Second Preliminary Consultation
MONTGOMERY COUNTY HISTORIC PRESERVATION COMMISSION
STAFF REPORT

Address:	9832 Capitol View Ave., Silver Spring	Meeting Date:	11/15/2023
Resource:	Spatial (undeveloped) Capitol View Park Historic District	Report Date:	11/8/2023
Applicant:	Mark Kaufman (Doug Mader, Architect; Phillip Long, Engineer)	Public Notice:	11/1/2023
Review:	2 nd Preliminary Consultation	Staff:	Dan Bruechert
Proposal:	Construction of single-family dwelling, tree clearing, hardscape, and associated sitework

Figure 5: Streetscape study created for the February 7, 2022 Preliminary Consultation (a full-size version is included with the application materials after this report).

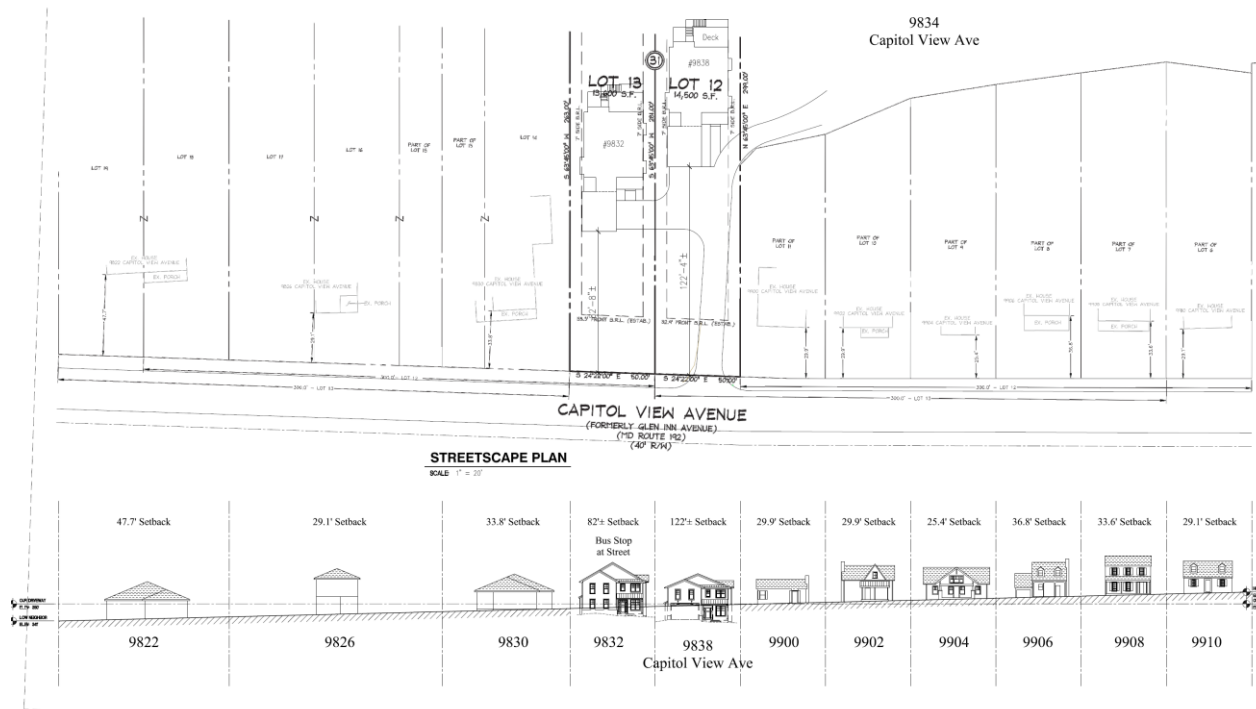
At the previous Preliminary Consultation (which included both 9838 and 9832 Capitol View Ave.), Staff requested the applicant provide a streetscape study to better evaluate the compatibility of the proposed construction with the immediately surrounding district. The proposed house at the subject property has been relocated nearly 50' (fifty feet) closer to Capitol View Ave. and, due to the rise in grade, will appear much taller than what was presented in early 2022.

Staff finds the proposed house threatens to overwhelm the house at 9830 Capitol View Ave. as presented. The house should be lowered so that it presents as two full stories and no more on the façade. Staff also finds that breaking up the house massing, particularly at the front, would help the house appear smaller and more compatible with the character of the district. This could be accomplished by creating roof form with two gables, like the infill construction at 9905 Capitol View Ave. or a gable-L form at the approved house at 10201 Menlo Avenue.

- An updated HAWP application form with all relevant project information;
- Building height from first floor to the top of the principal ridge from all elevations;
- An updated streetscape study that reflects the new house placement;
- An updated tree removal and planting plan;
- An updated site plan that shows the new building and setbacks from each wall plane to all confronting property lines; and,

dd1

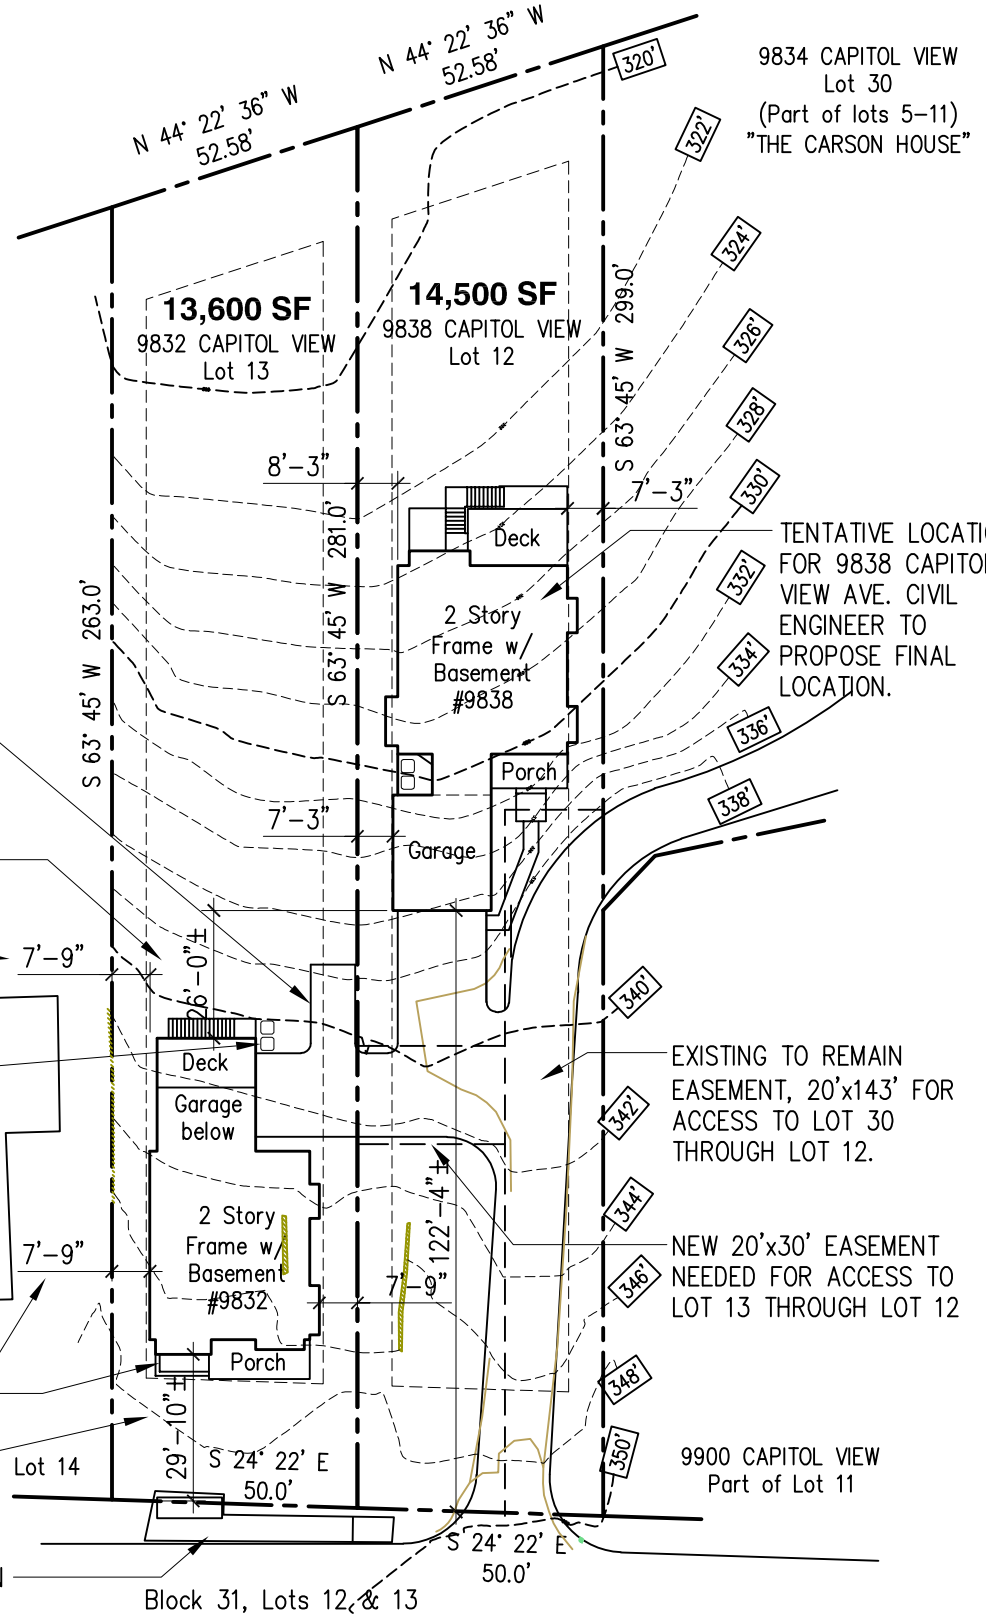
Based on feedback at the Preliminary Consultation, the applicant has reorganized the plan for the house, so the attached, side loading garage is at the rear. This change allows the house to be located much closer to the street, however, a portion of the proposed house will be obscured by the existing bus shelter. Many of the houses to the north of the subject property along Capitol View Ave. are closer to the street than current zoning allows. Staff finds the revised front setback is consistent with its neighbors- and reinforces the existing pattern of construction along the streetscape. This change was recommended by a majority of the HPC at the February 2, 2022 Preliminary Consultation.

The HAWP submission for 9838 Capitol View Ave. included a stormwater management and tree removal plan that included the subject property. It has been nearly a year and a half since that plan was prepared. Because the lengthy interval between completing that plan and because the applicant did not indicate that plan will be relied on for this project, Staff does not include a discussion of the tree removals or proposed hardscape alterations in this report. The applicant must submit (or resubmit) the stormwater management/sediment control/tree removal plan for the HAWP application to be considered complete.

The house will be placed near the street, with a 29' 10" (twenty-nine feet, ten inch) front setback. The house will have 7' 9" (seven feet, nine inch) setbacks on either side. Combined with the 11' (eleven foot) setback at the rear of 9830 Capitol View Ave., the two houses, at their closest, would be separated by 18' 9" (eighteen feet, nine inches). Staff's measurement shows that the primary mass of 9830 Capitol View Ave. is approximately 15' 6" (fifteen feet, six inches) to the south of the property line.

dd7
 7 of 12

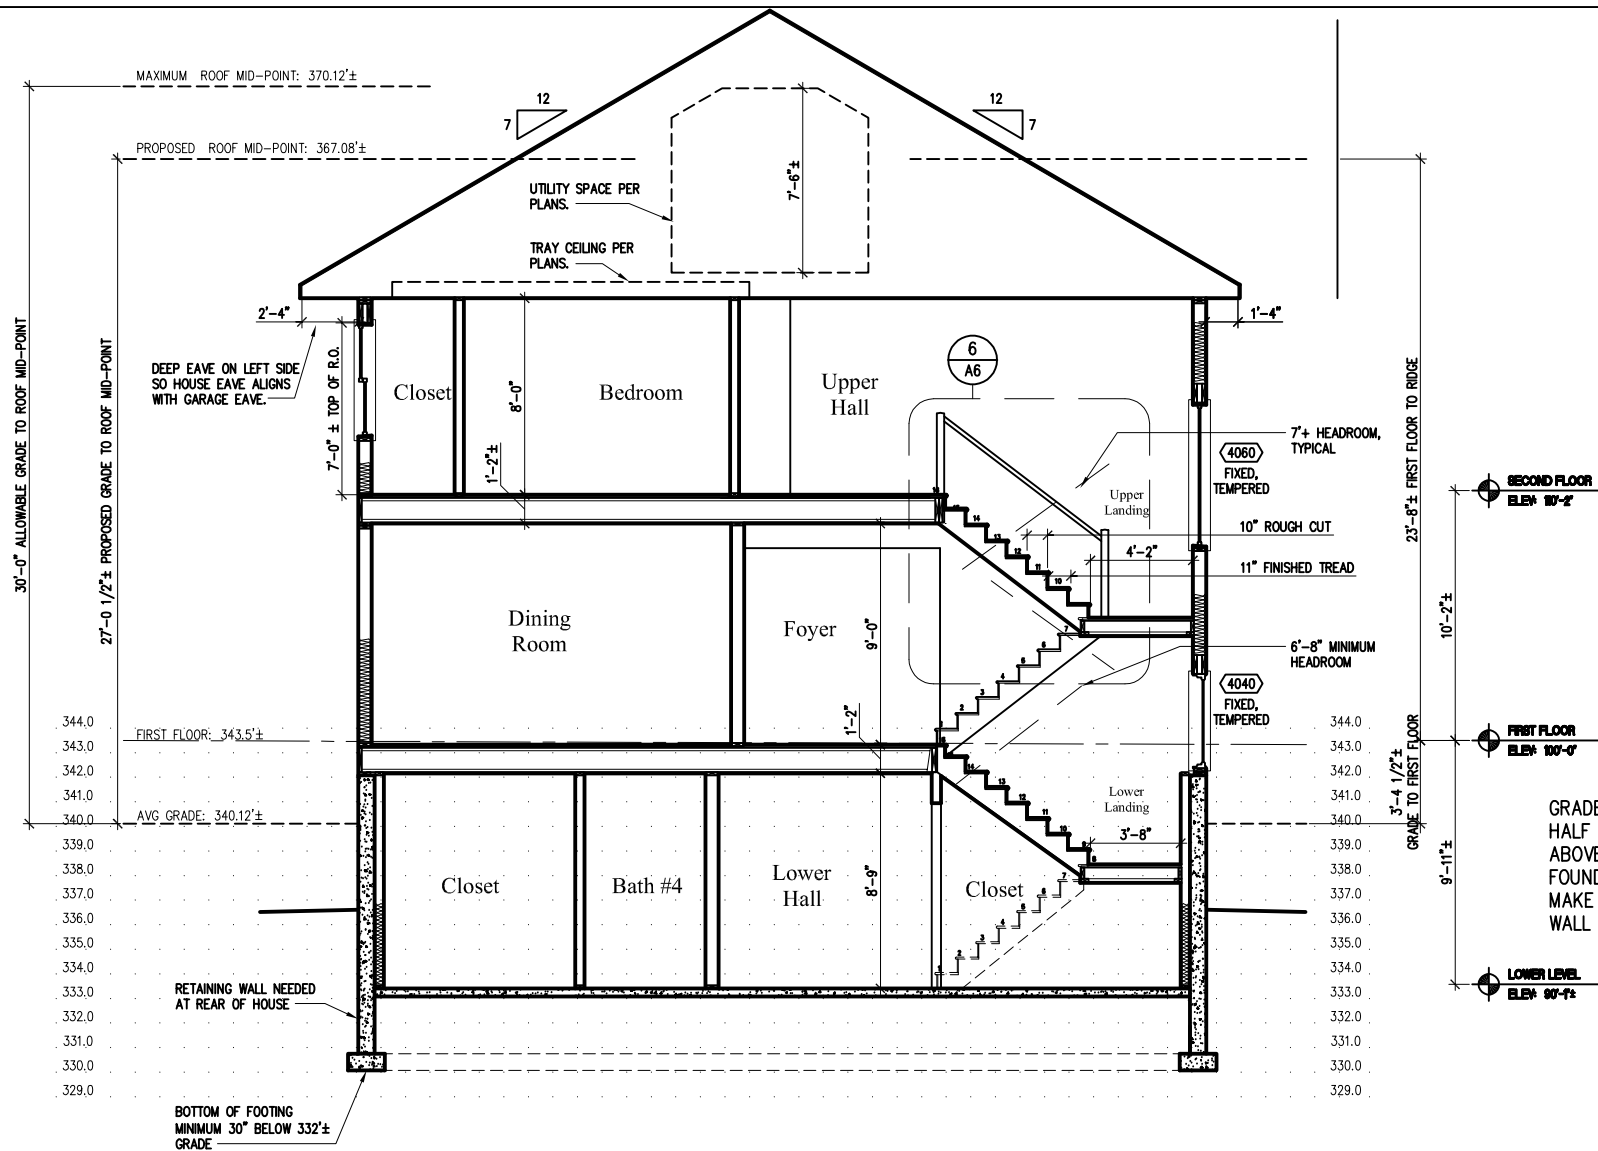
The proposed house is two-stories tall with an attached side loading two-car garage at the basement level. The main house mass measures 46' 4" × 32' 6" (forty-six feet, four inches deep by thirty-two feet, six inches wide), with an additional 13' × 20' (thirteen foot deep by twenty foot wide) section above the attached garage in the rear. The submitted information does not include the fully occupiable square footage of the proposed house. The submitted drawings appear to present conflicting information about

the proposed house height. Sheet dd7 states the height from the first floor to the ridge is 23' 8" (twenty-three feet, eight inches), while sheet dd9 provides a first floor to roof mid-point measurement of 24' 1" (twenty-four feet, one inch). A correct measurement from the first floor to the principal gable ridge needs to be provided with the HAWP application.

dd9

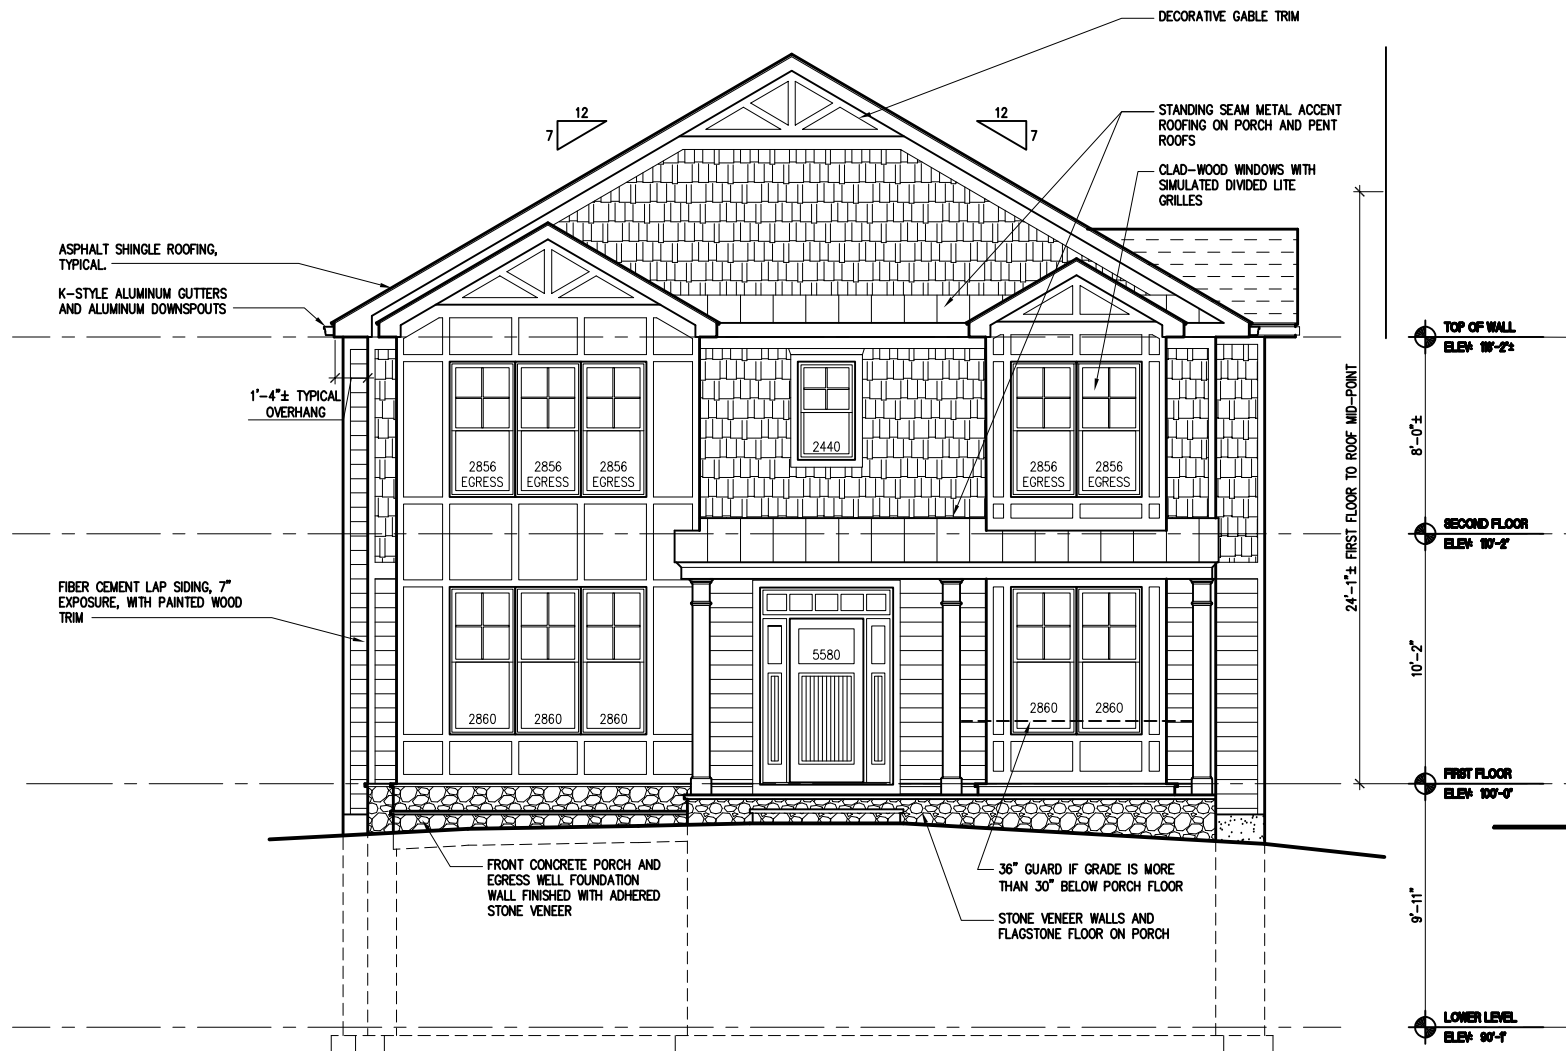
The house draws largely from a traditional architectural vocabulary and has a front gable roof, with a small front porch with a shed roof. There is a small, front gable projection on the left side of the front elevation and a smaller projection to the left of the central front door. The design elements are nearly identical to the approved HAWP at 9838 Capitol View Ave. discussed above.

The house has a parged concrete foundation, with a fiber cement clapboards on the first floor, and shingle second story (no material was provided for the proposed shingle siding). Staff notes, only the front and right elevations have shingled second stories; the left and rear are only sided in fiber cement clapboards. Staff finds the HPC has required consistent levels of finish on new construction and building additions; and the treatment on all four elevations should reflect that level of consistency. That does not mean that the HPC does not allow for a hierarchy of elevation in the design of this new construction, only that the HPC has not approved designs where a side elevation and rear do not receive the same level of care in their design. Additionally, staff finds that the porch is too narrow to read correctly as a traditional building element, there is too much paneling of inconsistent sizes surrounding the windows, and the

standing seam metal accents are out of character for the district. Other design embellishments appear to be applied, potentially resulting in an overall flat appearance for the house more consistent with builder-grade construction. The stone foundation is similarly out of character.
